Written feedback from Transport & Environment to the Commission on battery CF rules

During the meeting of the Expert Group on Batteries and Waste Batteries on 6 July 2023, participants were invited to send written feedback to the Commission on the draft report of the JRC that was presented during the meeting. The following input from Transport & Environment makes recommendations to improve the draft delegated act establishing the methodology for calculation and verification of the carbon footprint of electric vehicle batteries and builds on our previous position which can be found [here](#).

T&E would like to highlight three areas of concern raised by the latest draft report of the JRC on battery carbon footprint calculation rules.

Carbon footprint (CF) metric as proposed by JRC:

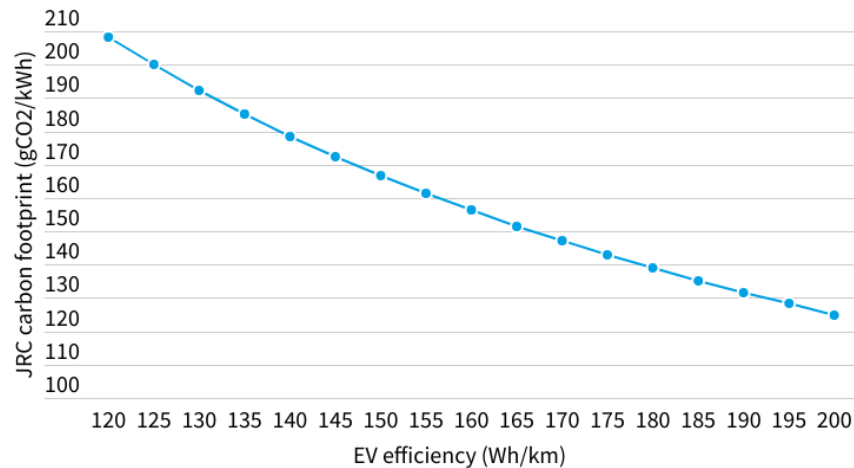
$$CF (gCO_2/kWh) = \text{total battery CF (gCO}_2\text{)} / \text{Quantity of vehicle FU (kWh)}$$

$$CF (gCO_2/kWh) = \text{total battery CF (gCO}_2\text{)} / (\text{EV efficiency (kWh/km)} * \text{EV lifetime (km)})$$

Under the metric proposed by JRC, the more energy inefficient the EV, the better the carbon footprint for the battery. Figure 1 below shows how the carbon footprint is lower (or better) for EVs with higher energy consumption per km. This illustrative example is based on a car with a fixed total battery carbon footprint (4 tonnes of CO₂¹) and a fixed EV lifetime of 160,000 km.

Figure 2: Carbon footprint as proposed by JRC illustrated by 4 EVs

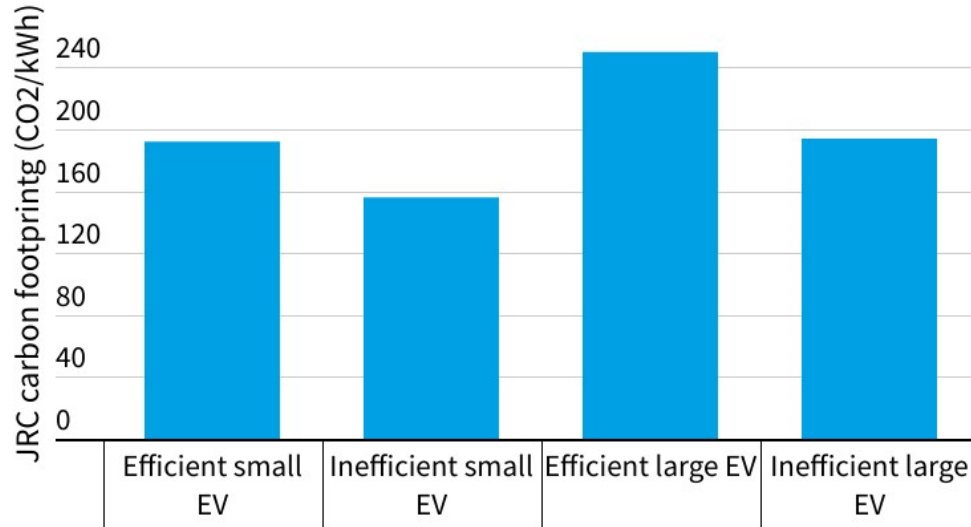
In a second example (see Figure 2 below), we model the outcome of the JRC battery carbon footprint approach on 4 different EVs using two different sized batteries (a smaller 50kWh and one larger 70kWh) in a more efficient and more inefficient model for each battery size. This approach accounts for the fact that EVs with bigger batteries are also usually less efficient. In this example it appears clearly again that, for a given battery size, inefficient vehicles are favoured (with a lower carbon footprint) over efficient ones, but also that in some situations an efficient EV with a small battery can have the same carbon footprint as an inefficient EV with a large battery.

The JRC’s application-specific approach is not acceptable as it would lead to carmakers prioritising the production of less efficient, heavier electric cars which are more expensive for consumers and less resource efficient². This would obstruct and potentially delay the development of a market for small, affordable electric cars in Europe.

Instead, the carbon footprint rules should focus on batteries as they are produced and come out of the factory, without covering parameters and characteristics of the vehicle, which is more simple and would avoid the risks outlined above.

By relying on the battery function unit instead of the vehicle functional unit as the denominator of the carbon footprint calculations, the battery regulation would effectively push for batteries made with green energy, efficient processes and favours chemistries that use less carbon intensive materials. It avoids any kind of mixing or diluting with other considerations about the EV.

Figure 3: How much battery makers can greenwash their carbon footprint with GOs

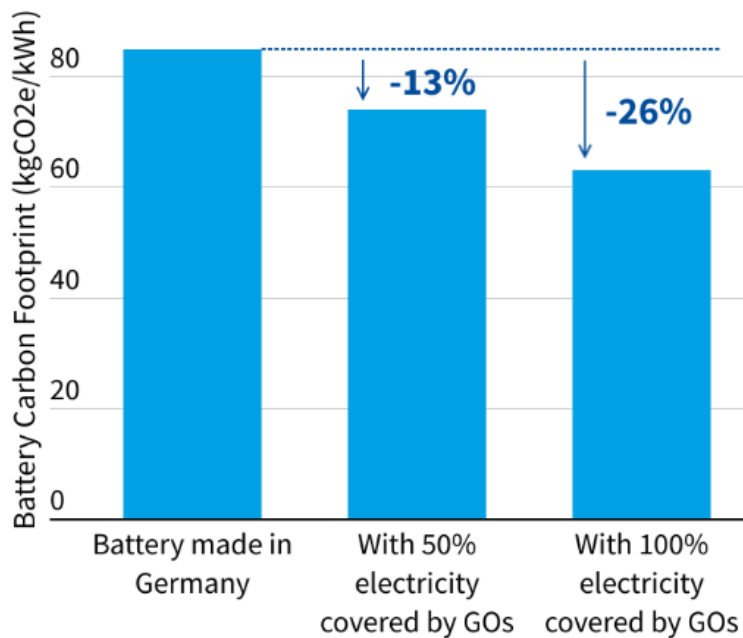
The current draft JRC report would allow companies to base their green energy claims on the purchase of Guarantees of Origin (GOs) throughout the entire EU market and over a 12-month period. This could be a problem as the current GO system does not account for real time energy sourcing or actual energy feeds between consumption and production and therefore cannot demonstrate cleaner battery production in the real world. Under the proposed rules, there is significant risk that battery makers would set up new production facilities in regions with a carbon intensive energy grid and then simply buy their way to an artificially low carbon footprint through renewable energy certificates with no temporal or geographical link to the production site, instead of incentivising investments in low carbon energy production facilities in those countries.

T&E estimates that battery makers in Germany, for example, would be able to artificially reduce - or greenwash - their carbon footprint by up to a quarter (26%) if they use GOs to claim and report 100% of their energy consumption as renewable for the production of the battery, even if they are connected to the grid (see Figure 3 below).

T&E recommends the following additional criteria for the use of renewable energy certificates as part of the battery carbon footprint calculation:

- **hourly matching between energy generation and use** (instead of 12 months) - or at the very least over a 6 hour period - to ensure a direct connection between energy that is being generated and consumed.
- **a clear geographic link between the energy generation and use**, including that the battery producing plant be located in and connected to the same bidding zone or adjacent interconnected bidding zones.
